**SUBJECT: COSUMNES POWER PLANT, APPLICATION FOR NPDES PERMIT
DISCHARGE**

Subject: REVIEW OF APPLICATION FOR NPDES PERMIT FOR COSUMNES POWER
PLANT, SACRAMENTO COUNTY, RESPONSE TO COMMENTS

COSUMNES POWER PLANT (01-AFC-19)

Cosumnes Power Plant
Application for NPDES Discharge Permit
Addendum B: April 25, 2002

FIGURE 8.14-3aR
PHASE I - ANNUAL AVERAGE
WATER BALANCE DIAGRAM
 COSUMNES POWER PLANT
 APPLICATION FOR CERTIFICATION
CH2MHILL

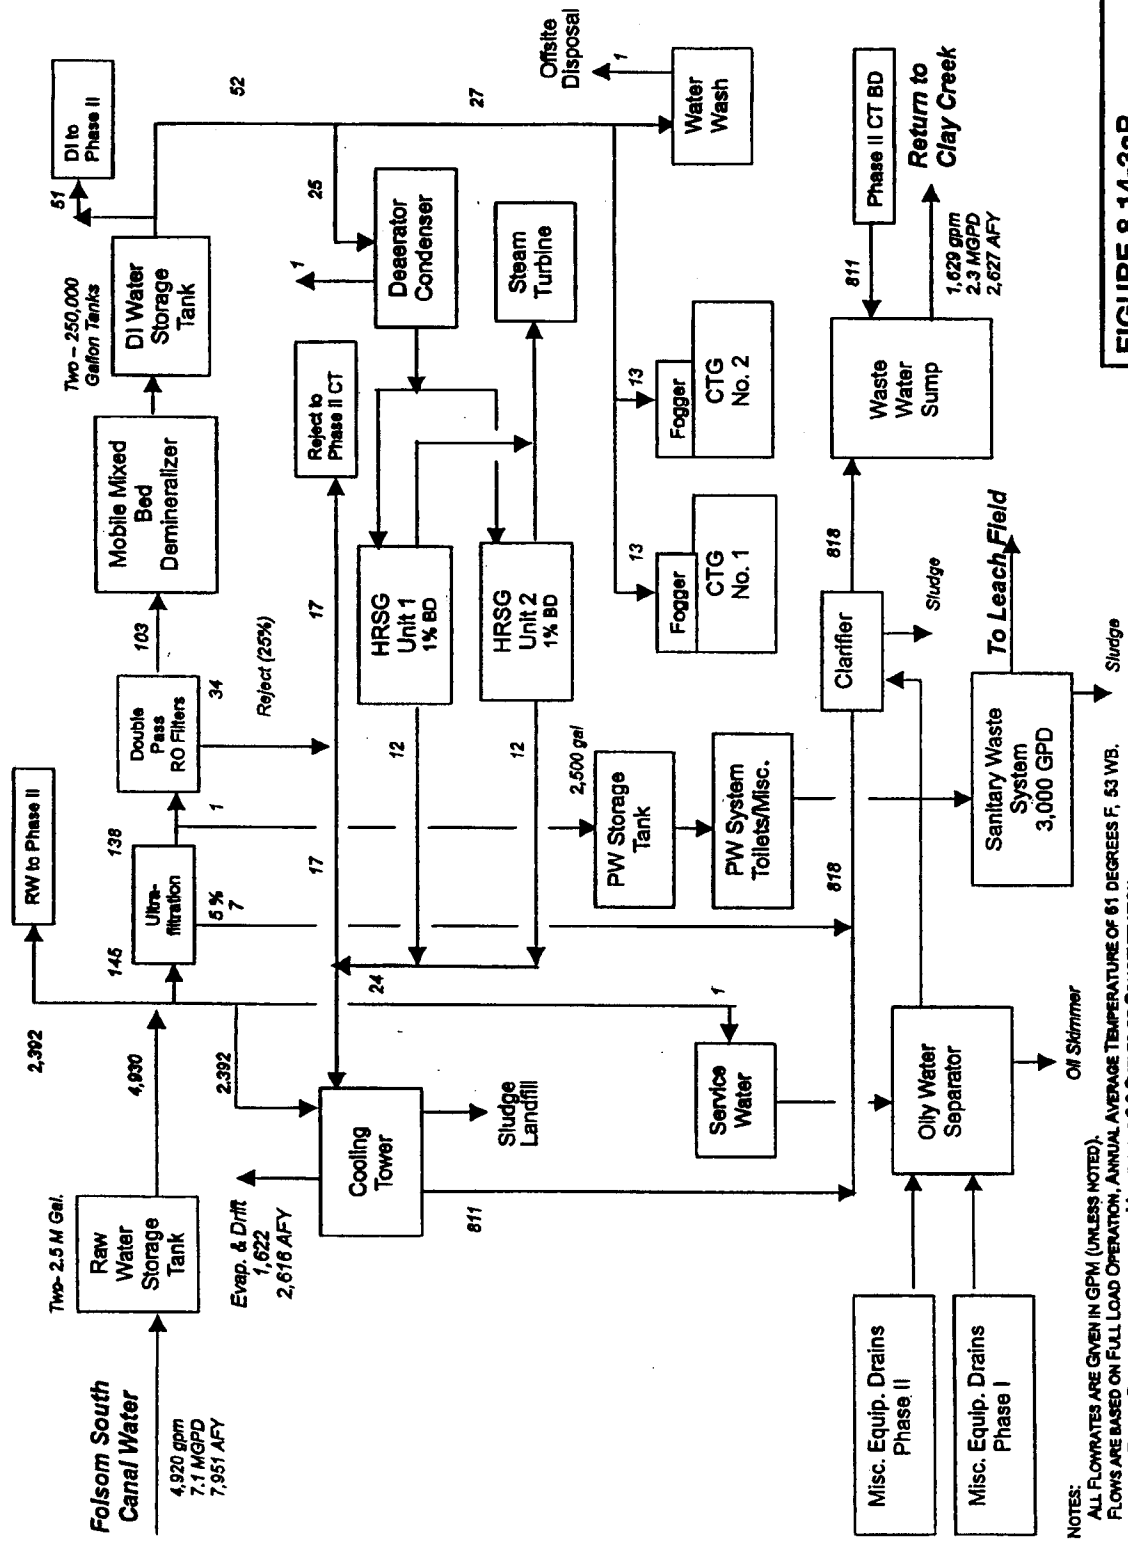
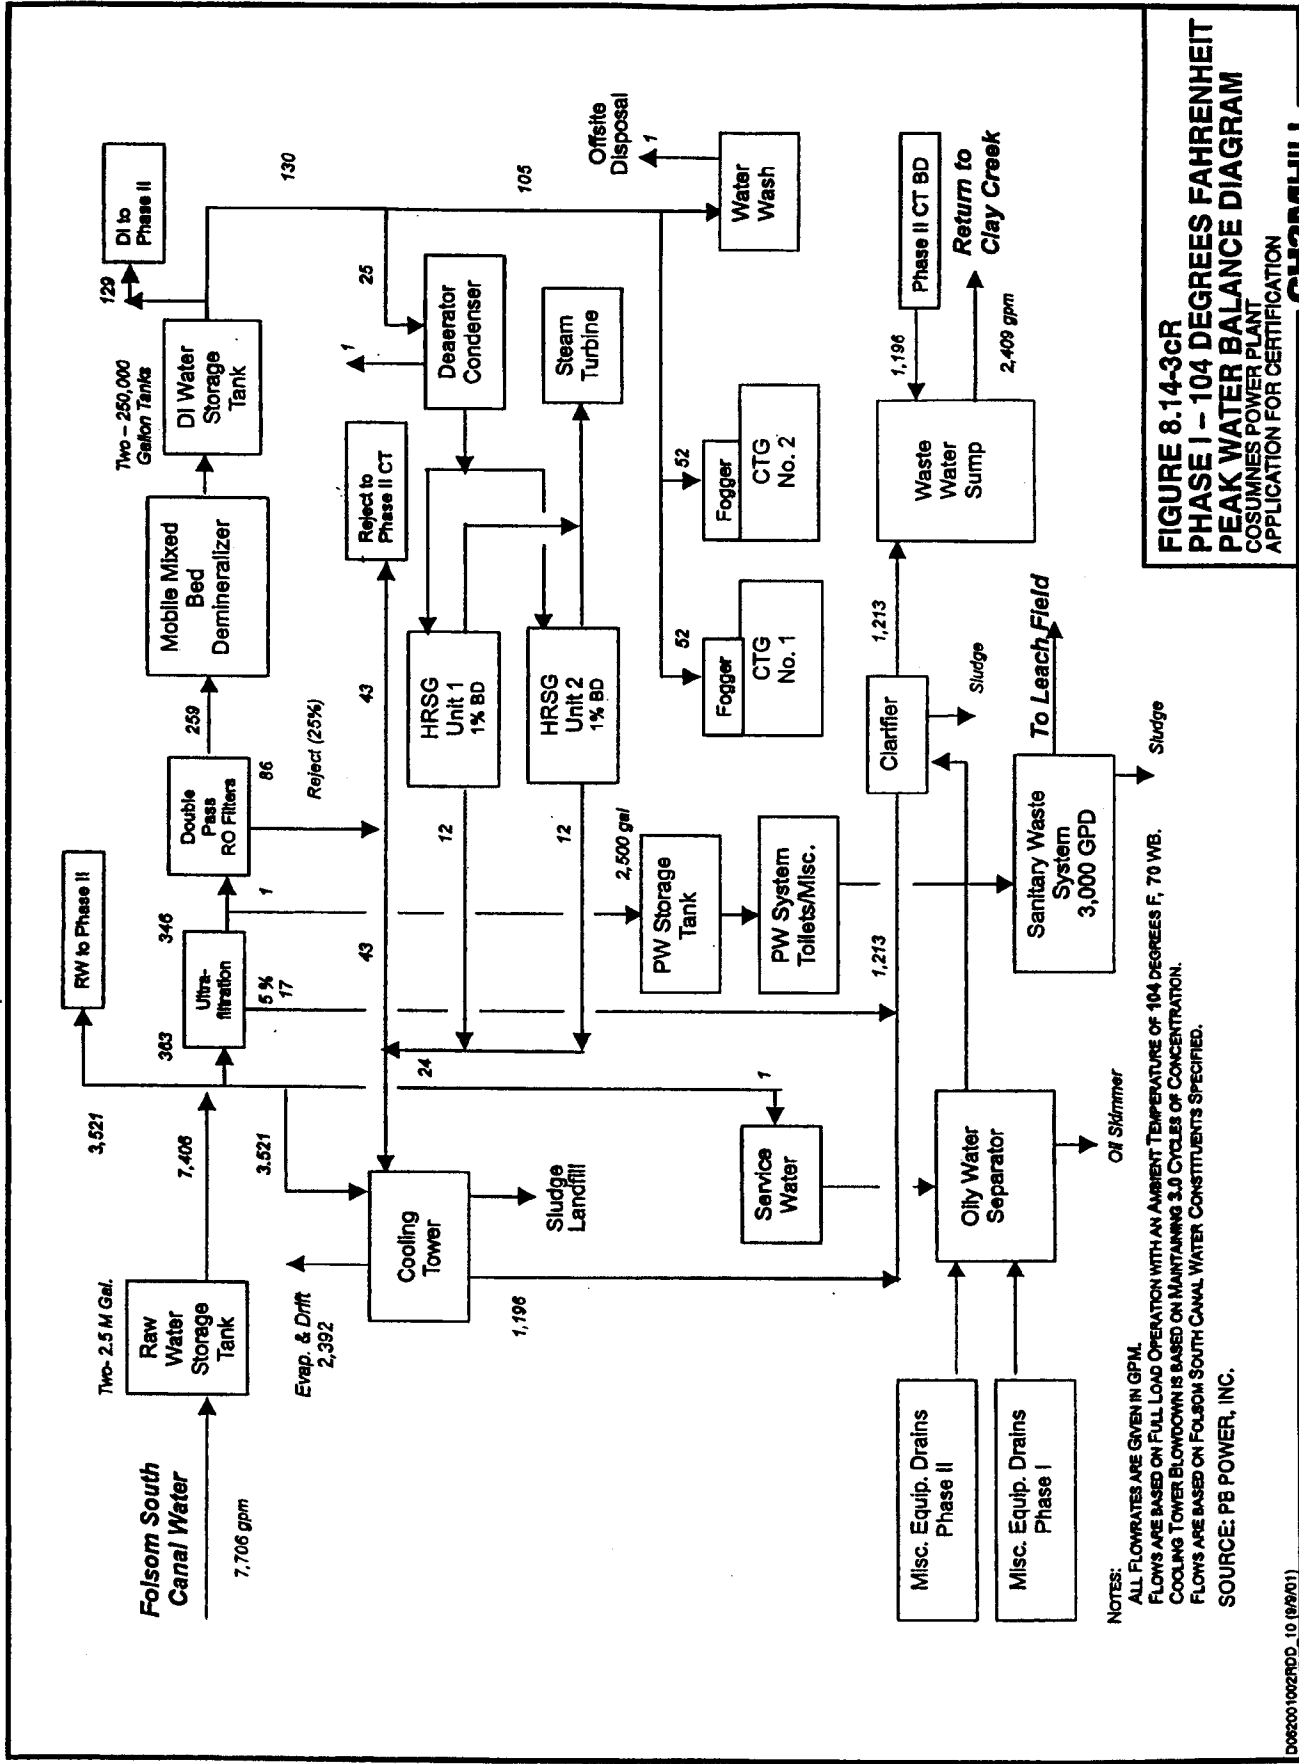
Thank you for the letter of January 29, 2002 from David Carlson of the Regional Water Quality Control Board ("RWQCB"), commenting on the AFC for the Cosumnes Power Plant ("CPP") project. As you know CH2M HILL submitted an application on behalf of the Sacramento Municipal Utility District (SMUD) for a CPP NPDES permit on January 21, 2002. The application had been modified from information in the AFC, based on your verbal suggestions. This letter is to respond individually and specifically to the items in RWQCB's January 29 letter, with a focus on issues relevant to having a complete NPDES application. As part of the certification process before the California Energy Commission, it is important to confirm when the NPDES application is deemed complete by the Regional Board and Regional Board review is underway. We therefore ask you to confirm completeness of the NPDES application, or let us know what specific further information you need for that determination. In addition, in conjunction with the certification process we are continuing to address water quality issues and impacts. We appreciate your input in that process, and the opportunity to continue discussions with you as your review proceeds.

4. Regarding equipment drains, and in response to RWQCB concerns, SMUD modified the water balance diagrams shown in the AFC to divert equipment drains to the oily-water separator and clarifier for treatment prior to monitoring and discharge under the NPDES permit. These modified diagrams were submitted as part of the NPDES application on January 29, 2002. A copy of those diagrams is attached to this letter for your convenience. We believe this is appropriate treatment for this water.

In figure 8.14-3aR, provided previously to the RWQCB (March 28, 2002), inflow from the raw water storage tank is shown as 7,406 gpm. 363 gpm goes to Ultrafiltration (UF) and then to Reverse Osmosis (RO), both of which produce reject. If ALL the salt from UF and RO go to the cooling tower, the contribution is $363/7406$ or 5%.
